Private Fuel Storage, L.L.C.

COMMITMENT RESOLUTION LETTER #10
DOCKET NO. 72-22 / TAC NO. L22462
PRIVATE FUEL STORAGE FACILITY
PRIVATE FUEL STORAGE L.L.C.

Subject: 50th Percentile Ground Motions

Figure 1 Horizontal Fault-normal Response Spectra

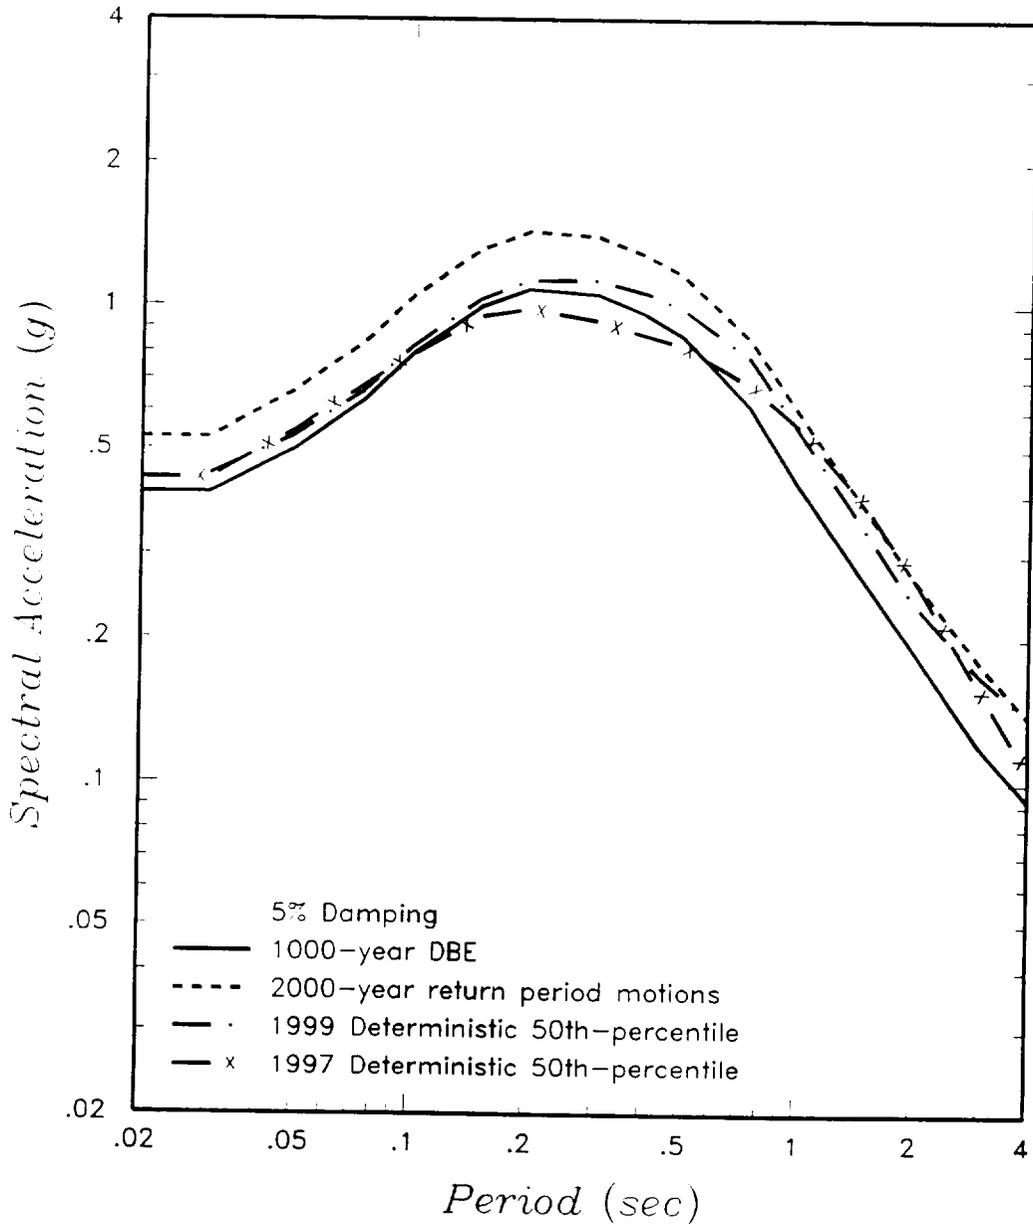
1. For the original deterministic analysis (1997), PFS should provide horizontal and vertical Peak Ground Acceleration (PGA) at the 50th percentile.
2. For the updated deterministic analysis (1999), PFS should provide horizontal and vertical PGA at the 50th percentile.
3. For the probabilistic analysis (1999), PFS should provide horizontal and vertical PGA for the 2000-yr return period.

The 50th percentile PGA values are 0.43g horizontal, 0.39g vertical.

The 50th percentile PGA values are 0.44g horizontal, 0.43g vertical.

The 2,000-year return period PGA values are 0.528g horizontal, 0.533g vertical.

The response spectra associated with these motions are compared on the attached figures for the horizontal fault-normal, horizontal fault-parallel, and vertical directions.
